CITY OF SAN DIEGO
GEOLOGY
RECORD DOCUMENT
PTS PROJECT NO.: 644432
DATE: 12/6/19

August 28, 2019 Project No. 11931.002

Subject: Geotechnical Response to City of San Diego
Cycle 7 BDR-Geology; L64A-003A
Federal Blvd M.O.
City of San Diego, PTS No. 644432

FIGURE 2
Geotechnical Map

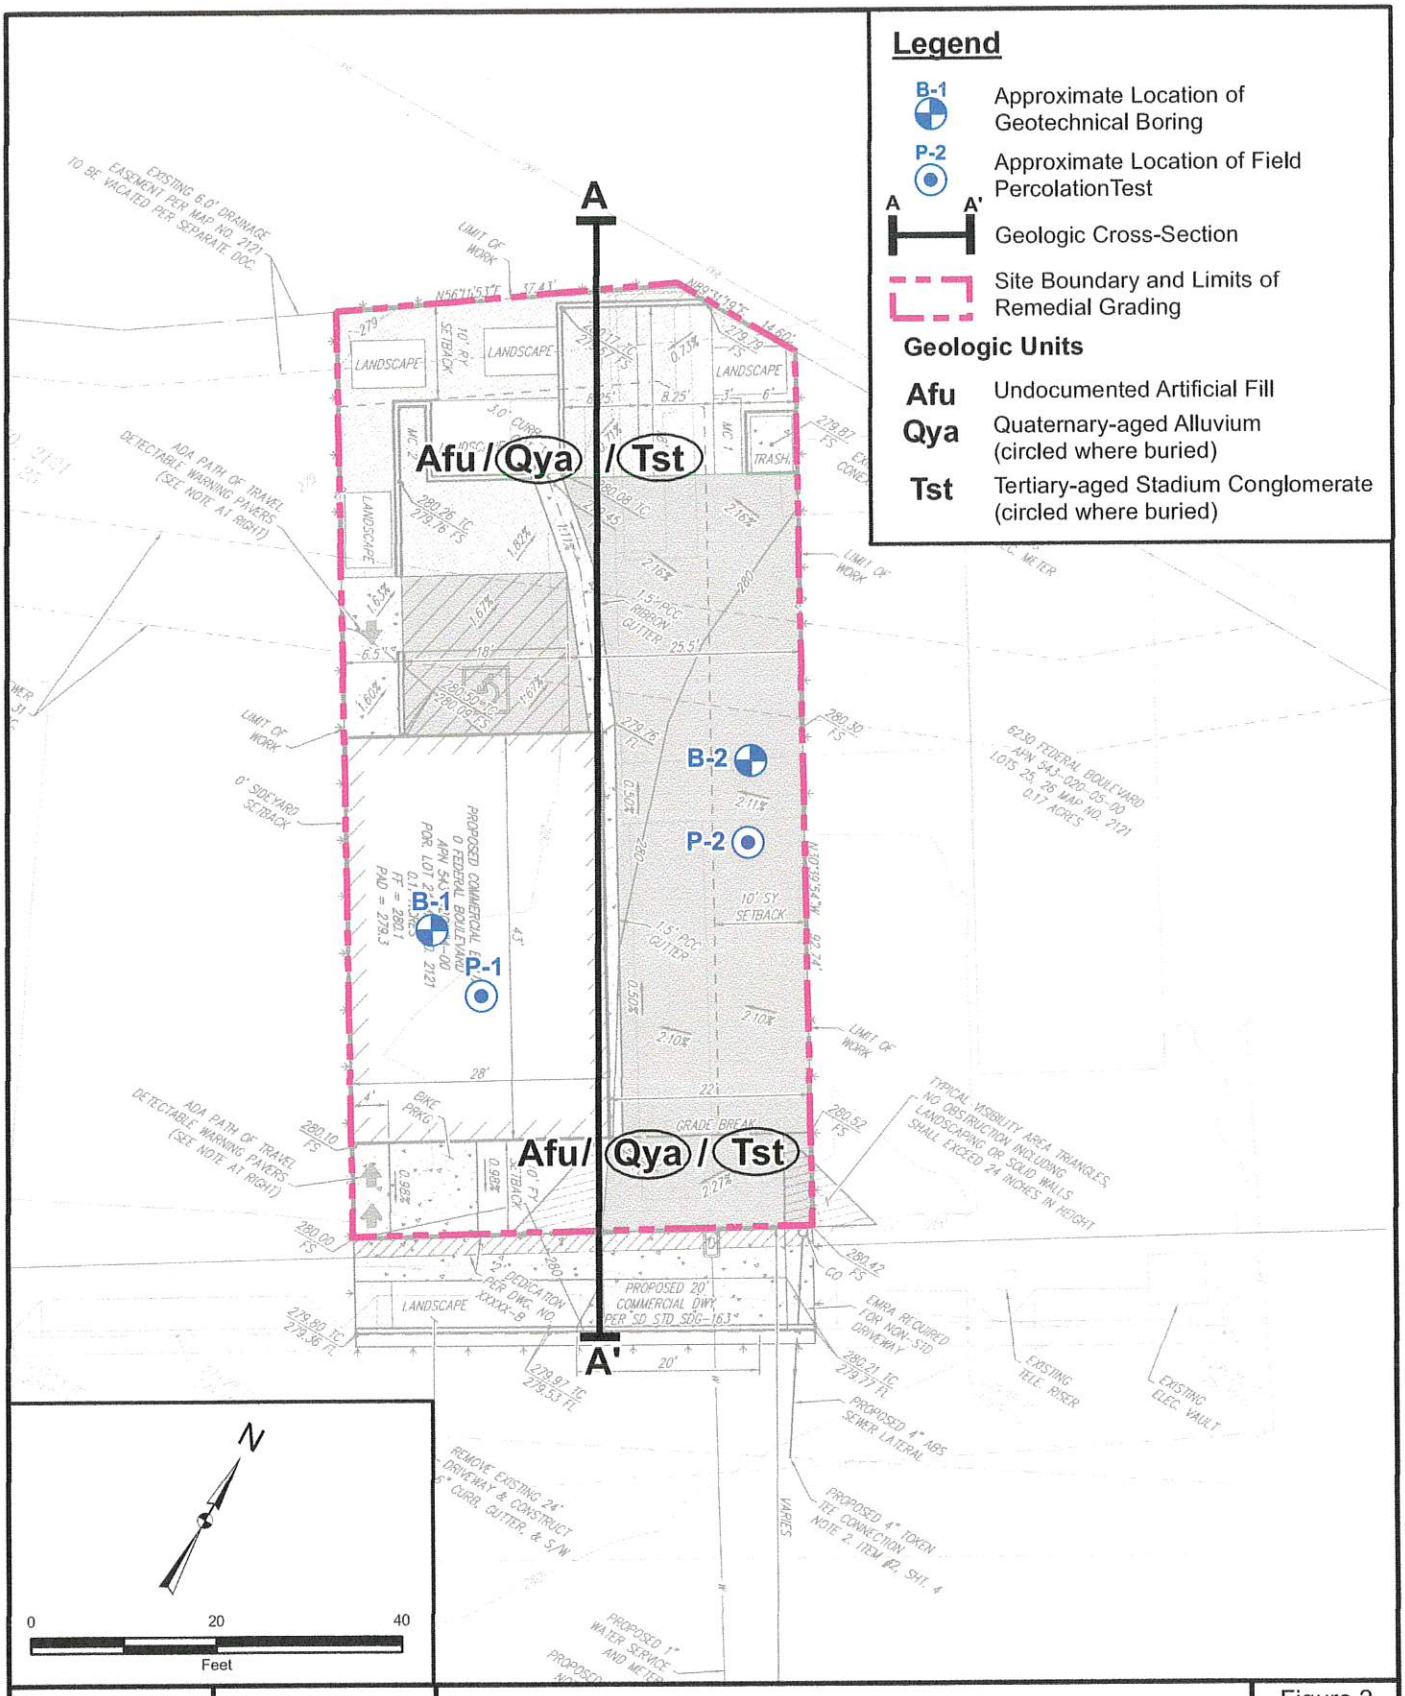
4 *Provide an updated/geotechnical map that shows the distribution of fill and geologic units, location of exploratory excavations, and current proposed construction on a topographic base map.*

See attached Figure 2 (Geotechnical Map).

FIGURE 2
Geotechnical Map

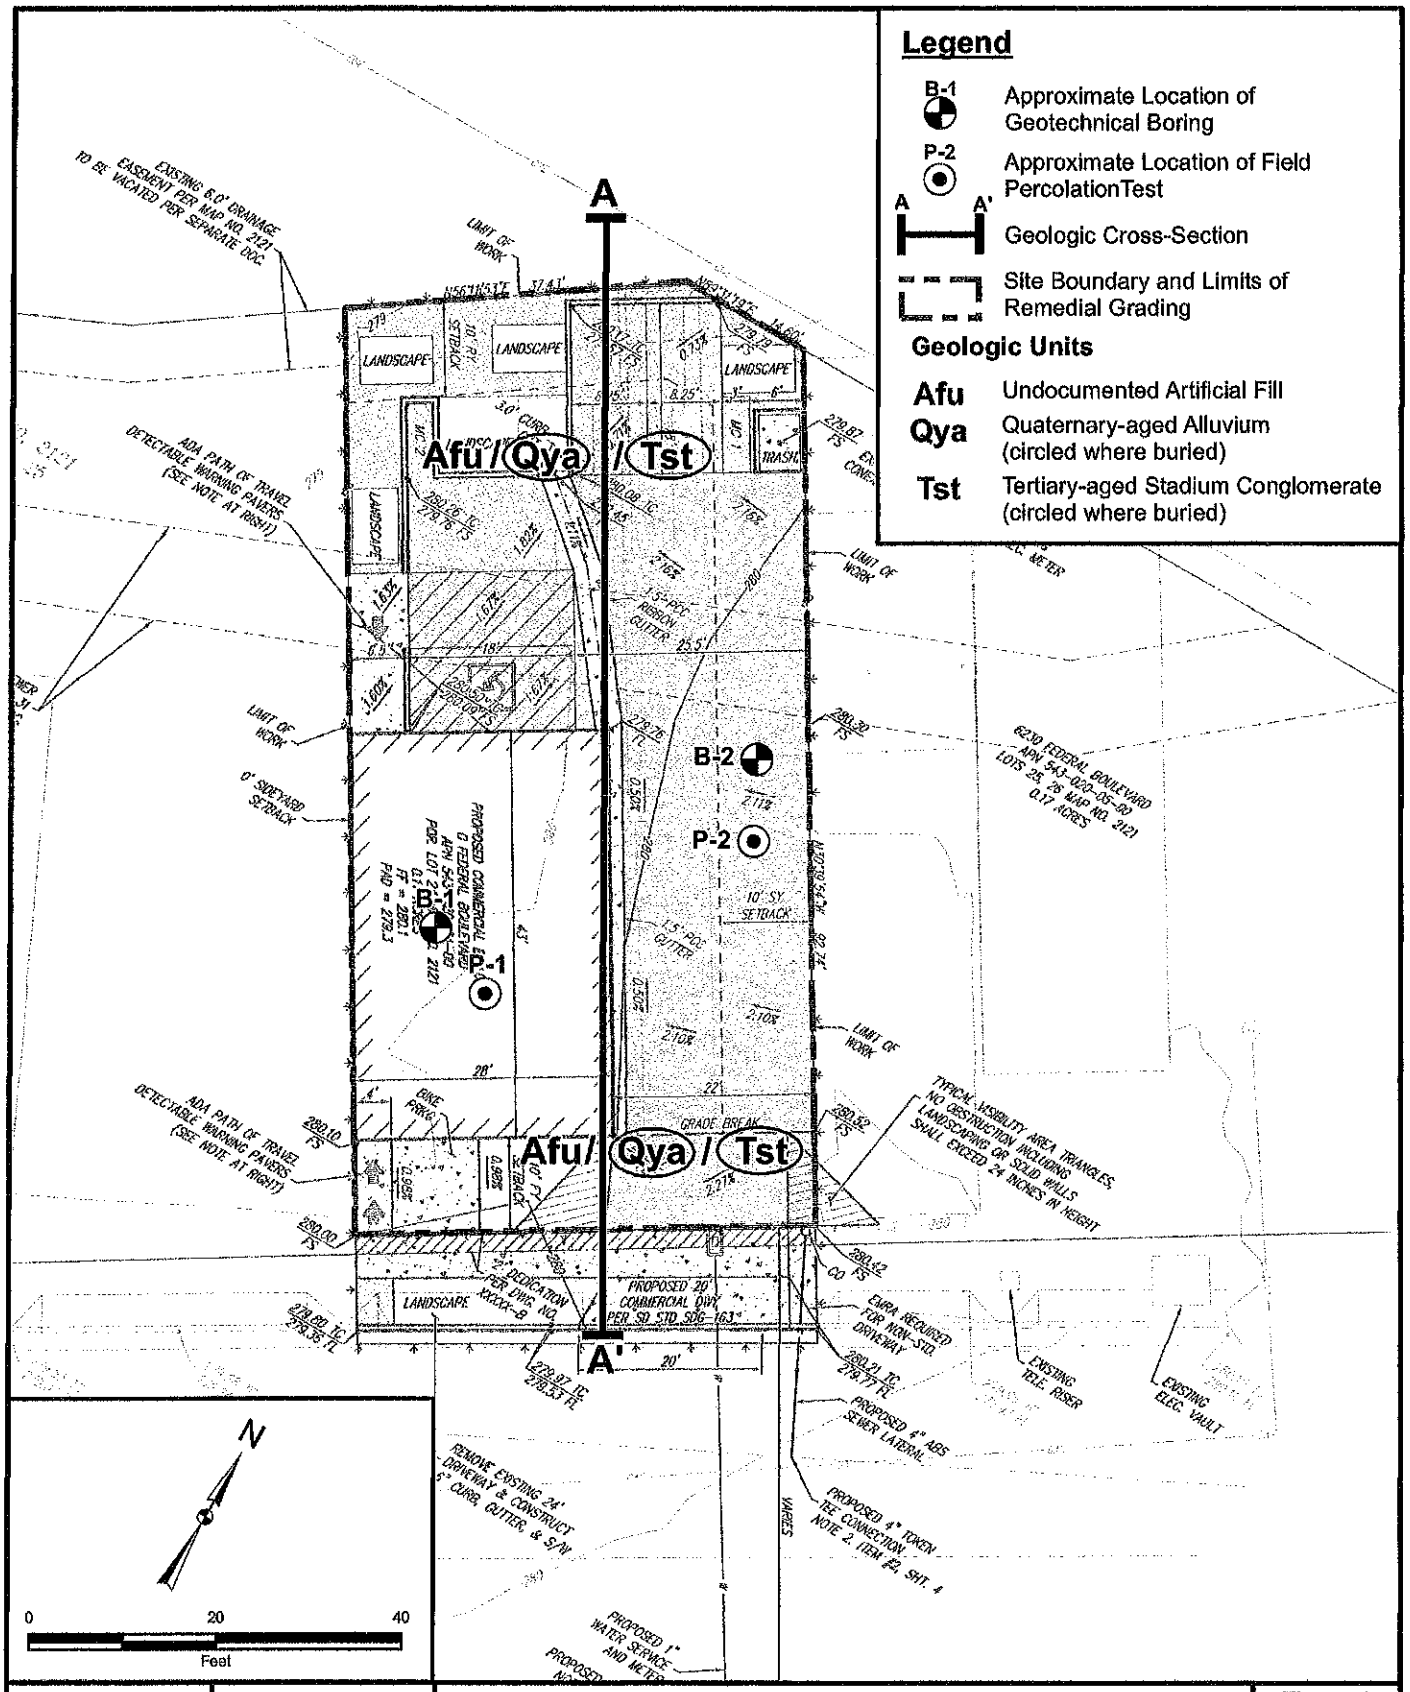
4 *Provide an updated/geotechnical map that shows the distribution of fill and geologic units, location of exploratory excavations, and current proposed construction on a topographic base map.*

See attached Figure 2 (Geotechnical Map).
